**DEFENSE NUCLEAR FACILITIES
SAFETY BOARD**

September 21, 2015

**OPPORTUNITIES FOR RISK REDUCTION AT THE
LOS ALAMOS NATIONAL LABORATORY
PLUTONIUM FACILITY THROUGH THE
MINIMIZATION OF MATERIAL-AT-RISK**

**Defense Nuclear Facilities Safety Board
Technical Report**

Figure 1: Distribution of residence times within a room for MAR and containers of nuclear material in PF-4

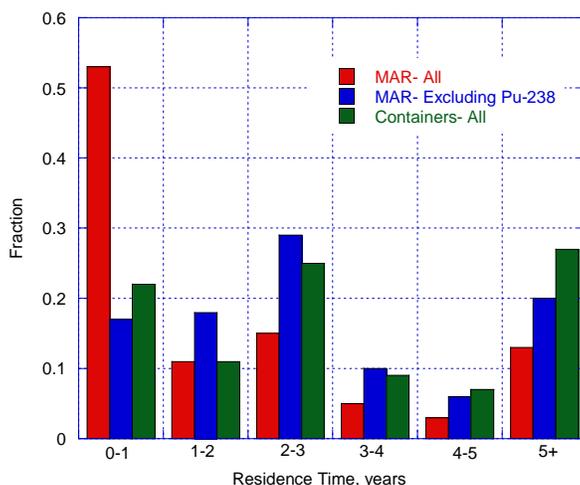
The Site Representatives selected 3 years as a useful delineation point because it extends the time interval beyond the past 2 years (during which many facility operations have been paused due to nuclear criticality safety and conduct of operations issues) and includes a year of normal operations. The picture of MAR usage can be further refined by excluding Pu-238 operations from the analysis due to their high MAR value when converted to Pu-239 equivalency, which can mask results for other categories of MAR. The results of this study indicate that 37 percent of non-Pu-238 MAR has been idle for at least 3 years, including 20 percent that has been idle greater than 5 years. The full distribution of residence times for MAR and containers is provided in Figure 1. Residence time data beyond 5 years was not readily retrievable, though the Site Representatives identified several items with residence times in excess of a decade. For example, operations personnel are working on disposition plans for various Pu-238 materials associated with the production of power sources for the Cassini space mission in the 1990s.

Some MAR is associated with long-term programmatic activities that require continuing residence on the first floor. However, based on discussions with the line managers responsible for operations, the Site Representatives determined that only about 10 kg of Pu-239 equivalent MAR is associated with this type of work in the form of measurement standards and materials supporting the long-term surveillance of containers under DOE Standard 3013-2012, *Stabilization, Packaging, and Storage of Plutonium-Bearing Materials*. This quantity represents less than one percent of the current MAR limit for the first floor. Overall, if one assumes the facility is operating near the allowable limit established in the approved safety basis, this finding indicates that more than 300 kg of Pu-239 equivalent could be moved off the first floor to more robust storage locations.

Figure 2: Profile of container types used for MAR storage on the first floor of PF-4 (left) and examples of a certified and non-certified container in a glovebox (right).

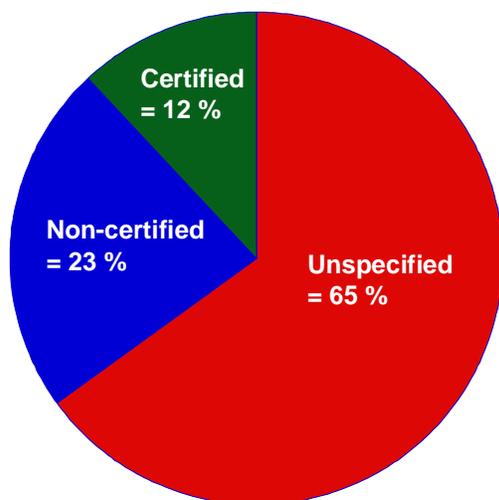
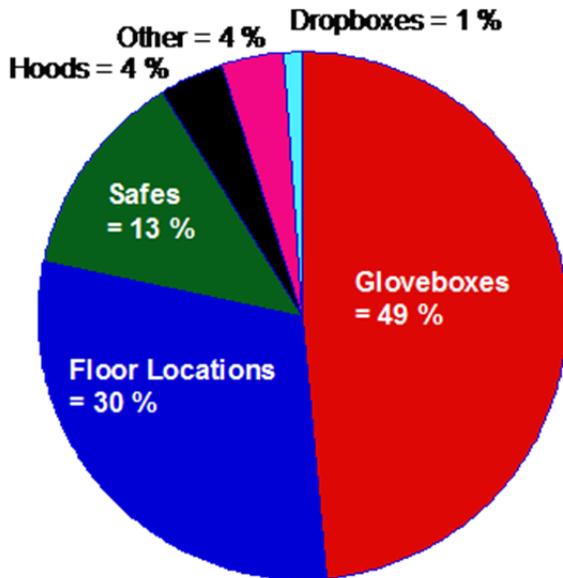
The safety basis credits certain certified containers as capable of protecting MAR from fire and drop insults. PF-4 personnel calculate their MAR inventory using data drawn from the Local Area Nuclear Material Accounting System (LANMAS). When performing a MAR calculation, PF-4 personnel are able to make reductions in the cumulative MAR inventory if workers specify in the database that the MAR is in certified containers. However, current procedures do not require the material handlers to enter the container type into the database. The database indicates that 12 percent of the containers are of a certified type (Figure 2), but walk-downs of the first floor by the Site Representatives suggest that the actual proportion of certified containers may be significantly higher. The database indicates that 23 percent of the containers are non-certified (e.g., generic “cans” or drums). Additional reductions in the existing MAR inventory (and possibly even credited MAR limits) may be possible by updating and maintaining an accurate database and transitioning away from the use of non-certified containers. One good practice observed by the Site Representatives is that the procedure for the vault requires workers to specify the container type in LANMAS prior to delivery to the vault. Extending this practice to all MAR movements could prove beneficial.
